## REMARKS

Appl'n No.: 09/819,330

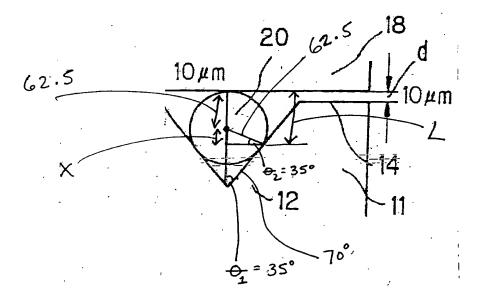
Fukuyama does not disclose, expressly or inherently, the numerical limitations recited in claims 1 and 3, which were discussed above in detail with respect to the §112 rejections asserted in the Office Action. An annotated version of a portion of Fukuyama's Fig. 3 is reproduced below.

As indicated in paragraph 7 of the Office Action, the diameter of Fukuyama's optical fiber is 125  $\mu$ m, which means that the radius (R) of the optical fiber is 62.5  $\mu$ m, and the angle of Fukuyama's V-groove is 70°, which makes  $\theta_1$  equal to 35°. Consequently,  $\theta_2$  shown in the annotated drawing is also 35°. The portion of Fukuyama's holding member that corresponds to (L), the claimed distance between contact point (P) and housing groove (4) and a surface of

cover plate (5) is equal to X + R, with R being equal to 62.5  $\mu$ m. "X" is equal to  $X = (\sin 35^{\circ})(R) = 35.8 \ \mu$ m. Accordingly, in Fukuyama, L would equal 35.8  $\mu$ m + 62.5  $\mu$ m, or 98.3  $\mu$ m. Since Fukuyama discloses that adhesive thickness (d), which corresponds to adhesive thickness (Y) recited in each of claims 1 and 3, is 10  $\mu$ m, adhesive thickness (d) is not at least 1/6 of distance (L), as claimed. Instead, as is clear from the above calculations based on the disclosure in Fukuyama, (d) is around 1/10 of distance (L).
